NUCLEAR REGULATORY COMMISSION (NRC) – BELLEFONTE NUCLEAR  
PLANT (BLN) – CHANGES TO ENVIRONMENTAL REPORT CHAPTER 8 – NEED  
FOR POWER

ENCLOSURE 2  
CHANGES TO BLN ENVIRONMENTAL REPORT CHAPTER 8 – NEED FOR POWER  
May 30, 2008

**CHANGES TO  
BELLEFONTE COLA, PART 3  
ENVIRONMENTAL REPORT  
CHAPTER 8 - NEED FOR POWER**

**FIGURE 8.2-9**  
**Regional vs. National Economic Growth**

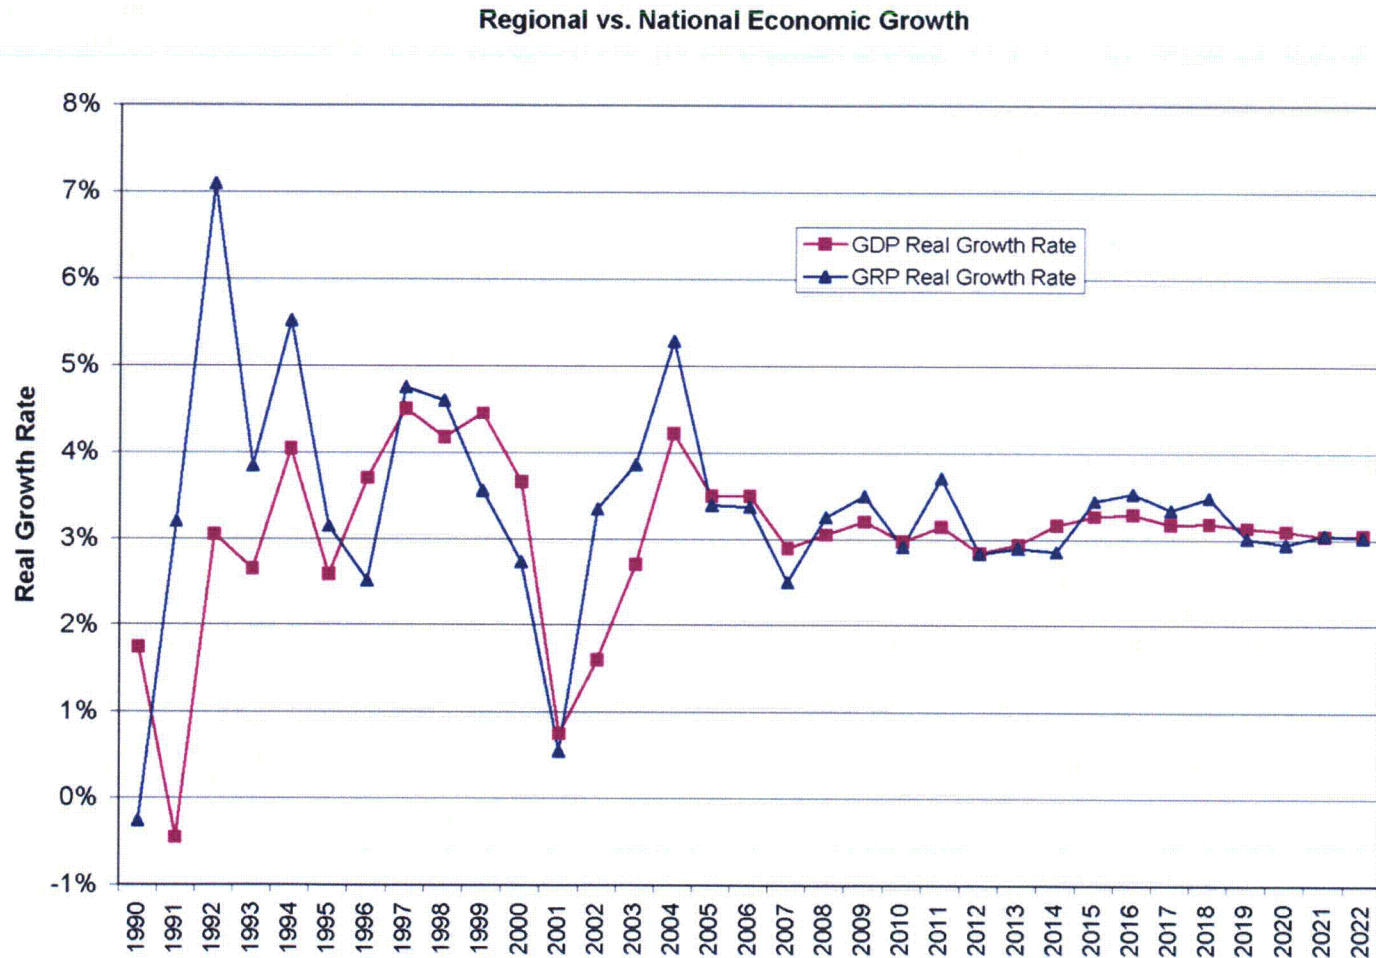
- Figure 8.2-9 is updated with current regional and national economic growth projections. These changes do not affect the corresponding text in Chapter 8.
- Table 8.2-5 is updated with current growth regional product (GRP) projections. Two values are updated: GRP for 2012-2017 and GRP for 2017-2022. These changes do not affect the corresponding text in Chapter 8.
- Table 8.2-7 is updated with current socioeconomic projections. Ten values are updated: all household and population values for 2012-2017; all household data for 2017-2022; and population data for the medium forecast for 2017-2022. These changes do not affect the corresponding text in Chapter 8.
- Table 8.2-8 is revised to include the Low forecast values that were inadvertently omitted from Table 8.2-8. These changes do not affect the corresponding text in Chapter 8.

5. Replace Figure 8.2-9 with the following figure:

**FIGURE 8.4-9**  
**Reduction in SO<sub>2</sub> Emissions due to BLN Unit 3 (2018) and BLN Unit 4 (2019)**

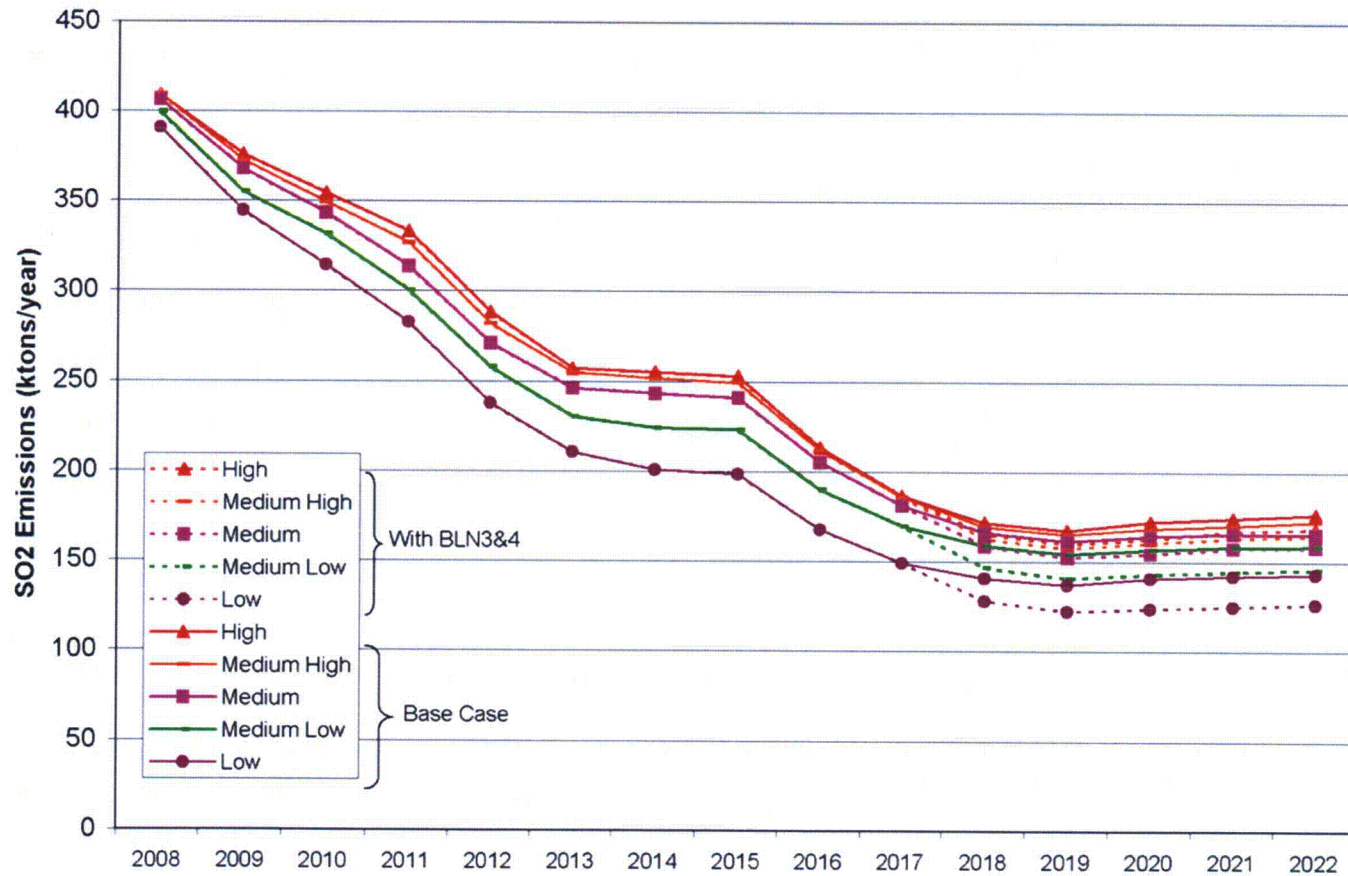
- Figure 8.4-9 is replaced with a revised figure. This is an editorial change to remove incorrect emissions projections (i.e., dashed lines). These changes do not affect the corresponding text in Chapter 8.
- Table 8.4-1 is updated with revised emissions reduction projections. These changes do not affect the corresponding text in Chapter 8.

7. Replace Figure 8.4-9 with the following figure:
